CIRCLE SQUARE PLOTS 2, 3 + 4
(FORMERLY KNOWN AS BBC SITE)
OXFORD ROAD, MANCHESTER

Non-Material Amendments
April 2020

3.2 BMU - Level 18

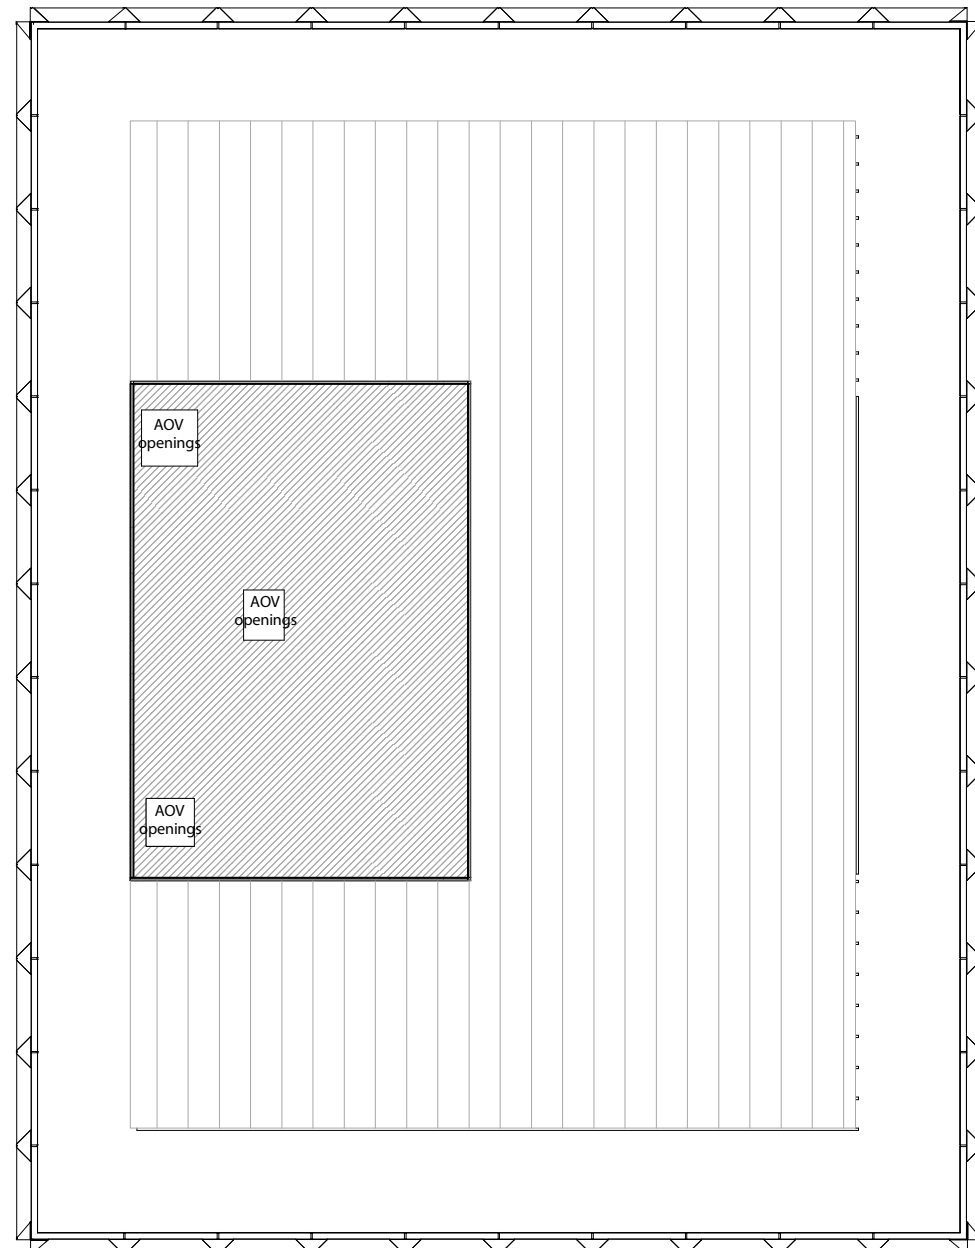
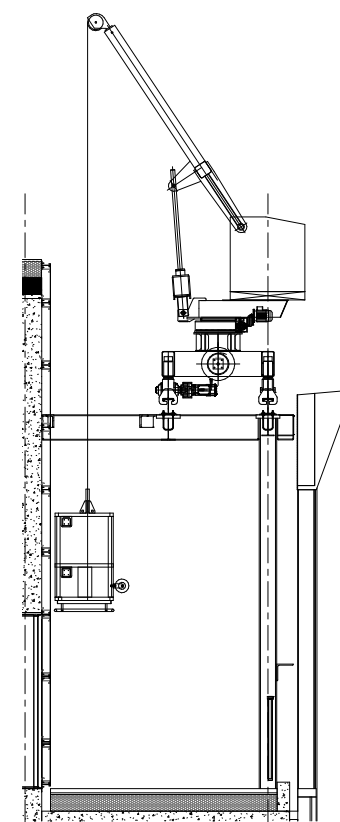
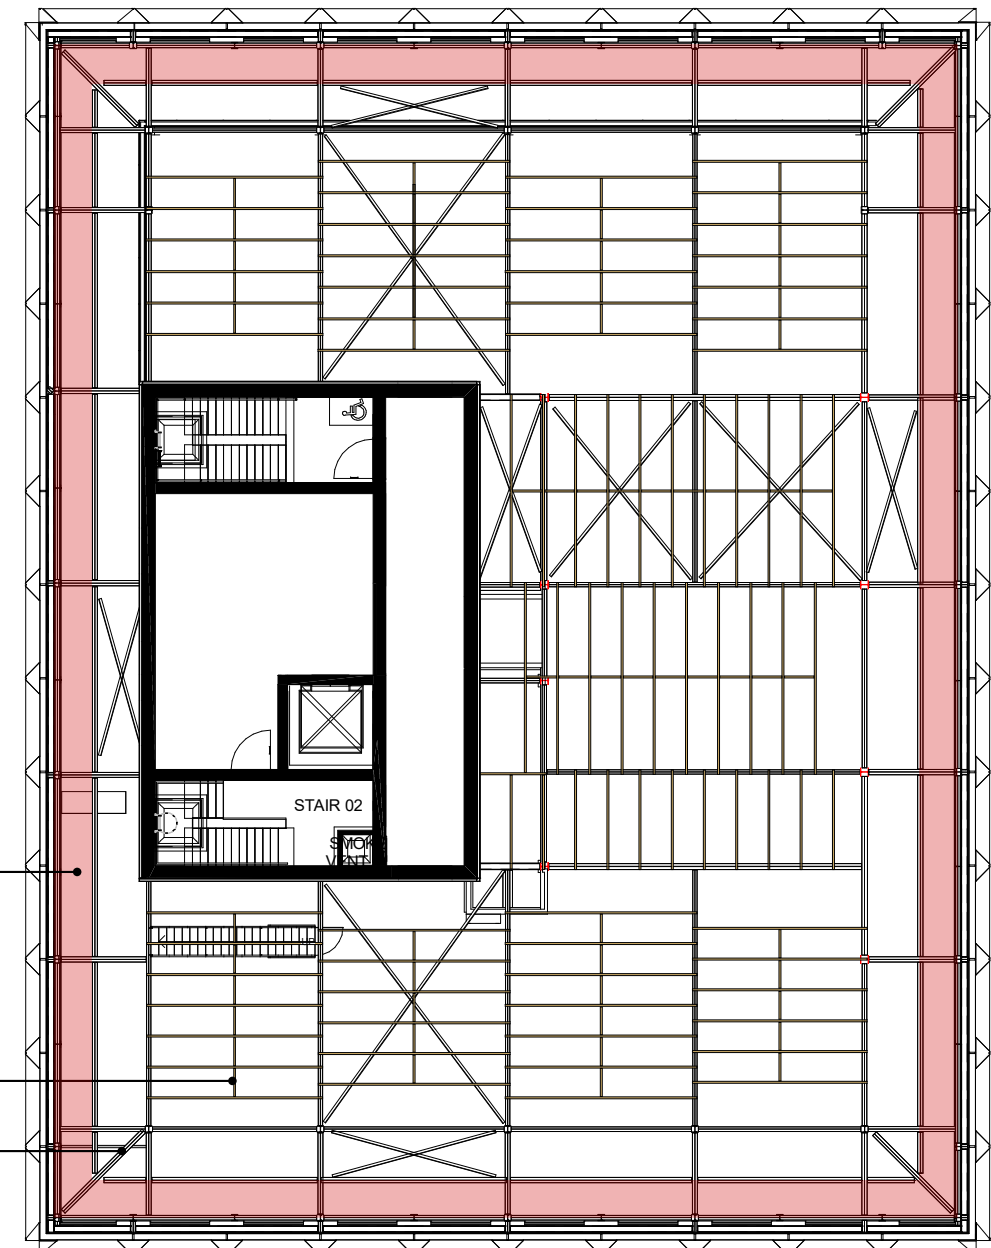
The BMU for Building 2 has changed from a mono rail to a two track fixed system. To allow for easy in maintenance and use, the cradle for BLD 2 will be stored on the lower level (Level 17) from the park position of the unit (on Level 18). There will also be a grating between the tracks and an access stair to allow for maintenance.

BMU updated and security grating added between the track around the perimeter (shown in section above)

Timber purlin setting out updated with removable panels where necessary

Steel structure shown below timber purlins

3.3 Roof terrace - Level 12

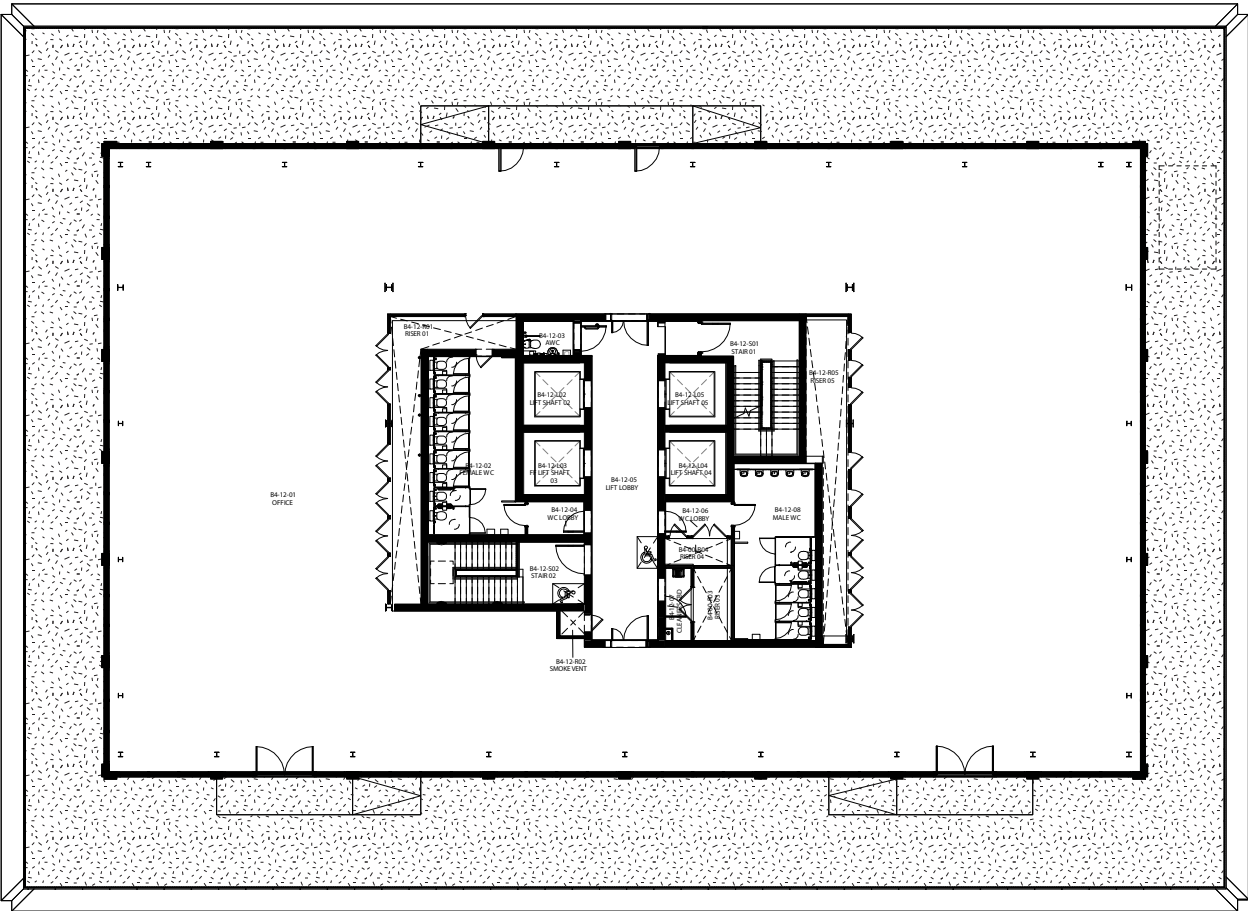
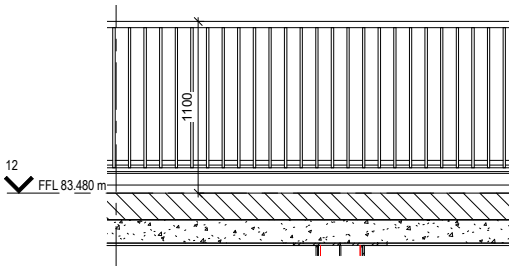
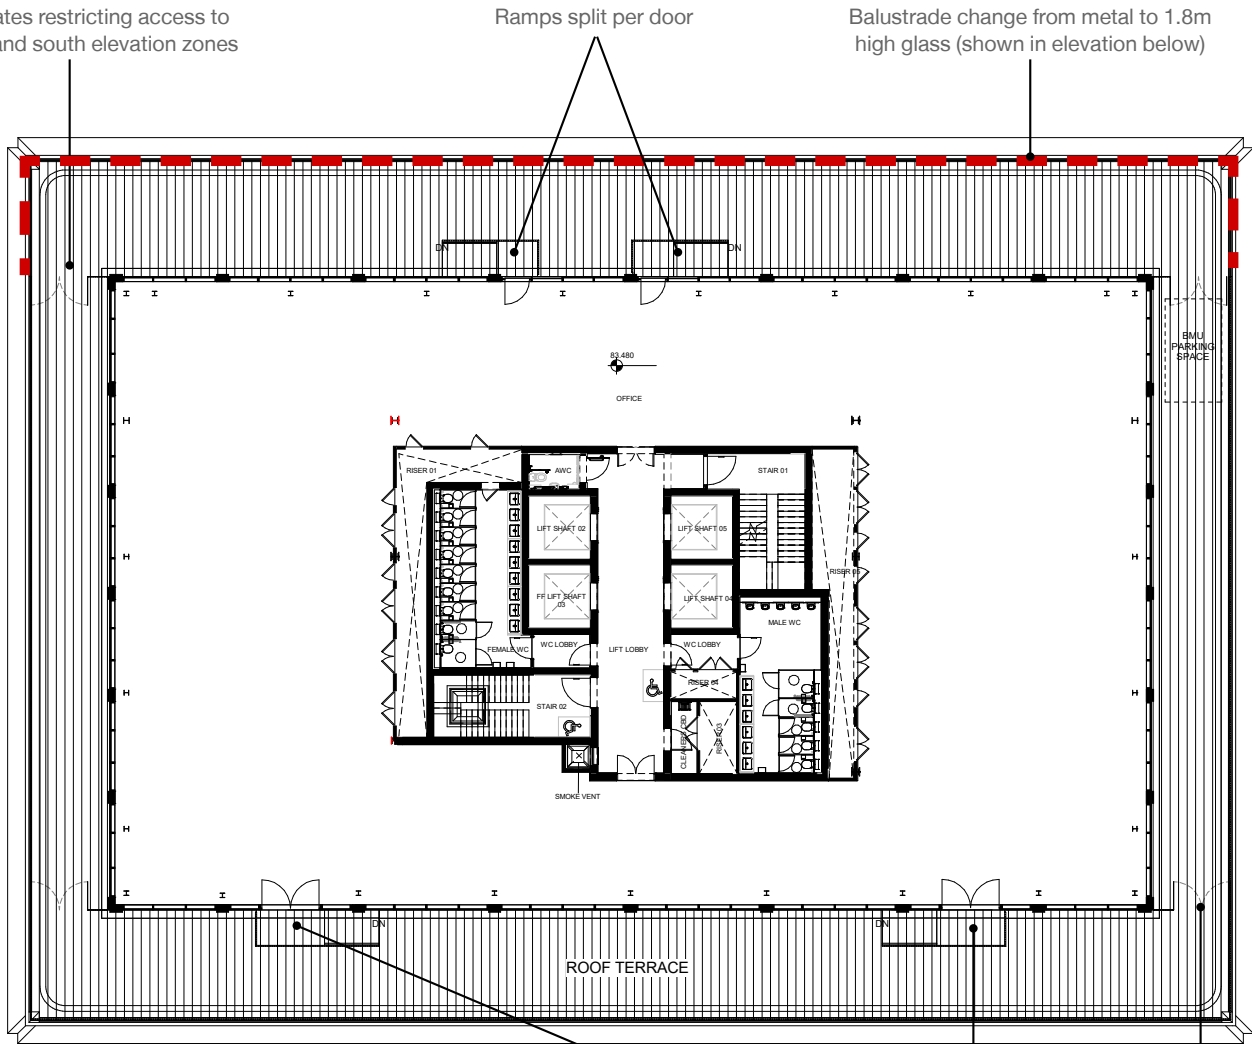
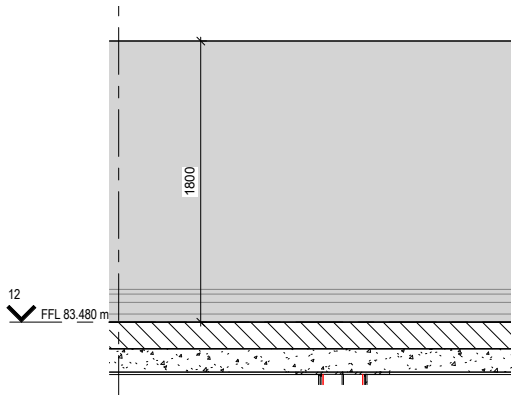
Metal balustrade around the Building 4 terrace changed from metal to glass on the western elevation (towards The Green side/Plot 3).

Stage 5 Current Balustrade Design (Dotted red line above)

Corner gates restricting access to the north and south elevation zones

Ramps size reduced to maximise terrace insulation

3.4 AOV Safety railing

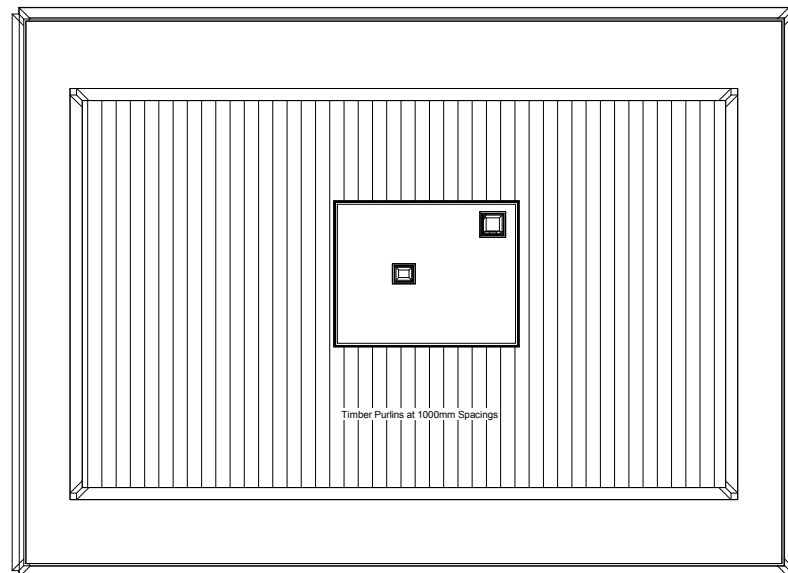
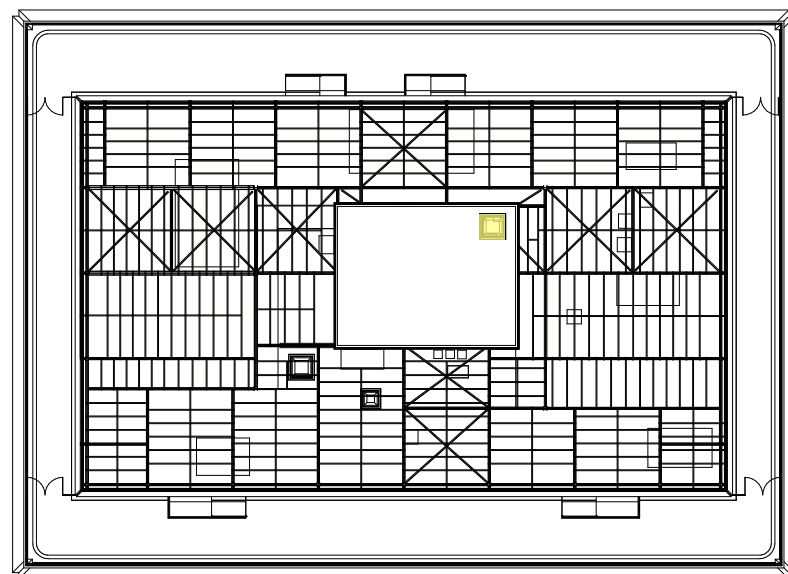
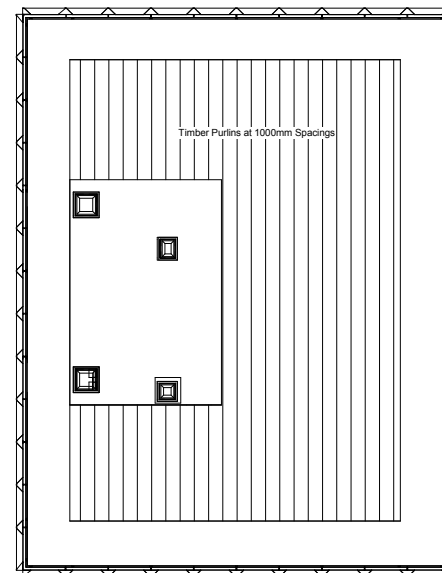
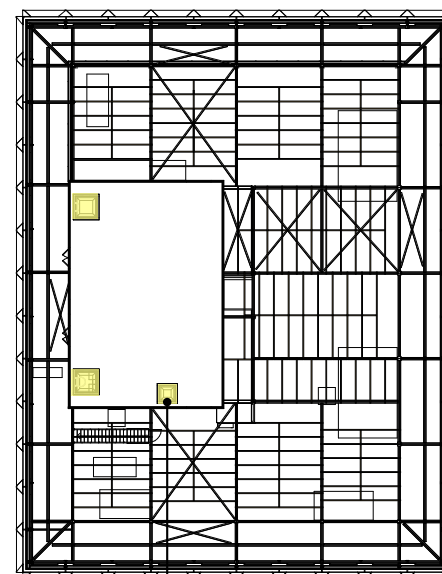
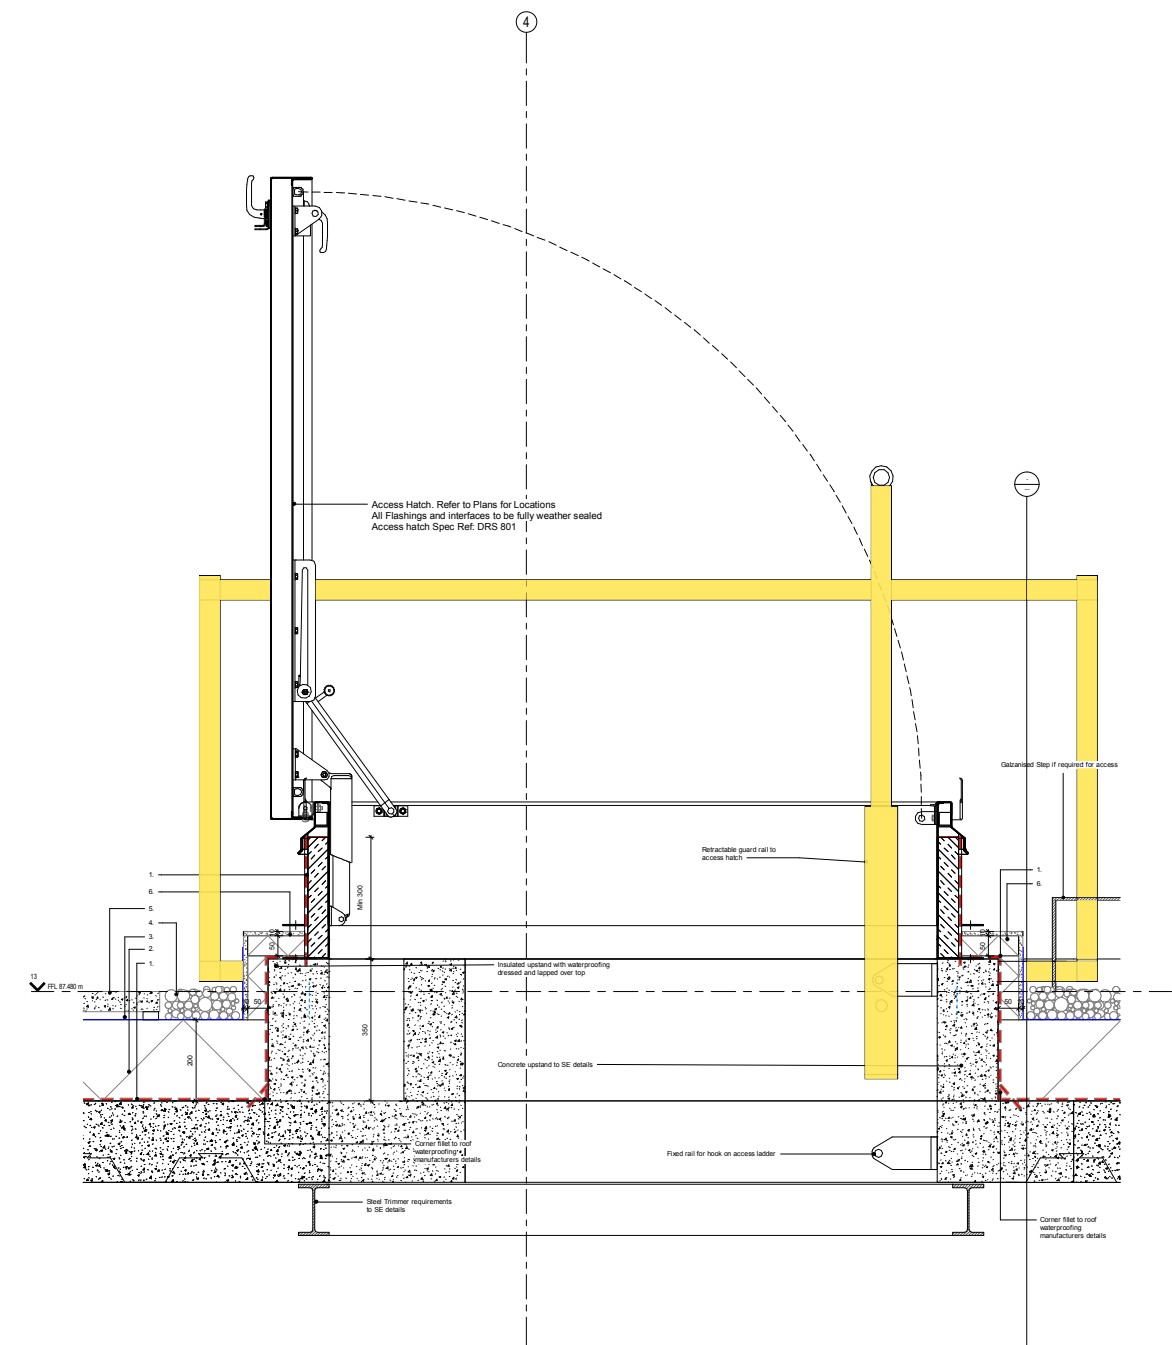
Following design development and clarity around the access strategy, safety rails will be provided around the AOV's to ensure safe access to the roof is available for routine maintenance.

AOV's requiring safety railing highlighted in yellow
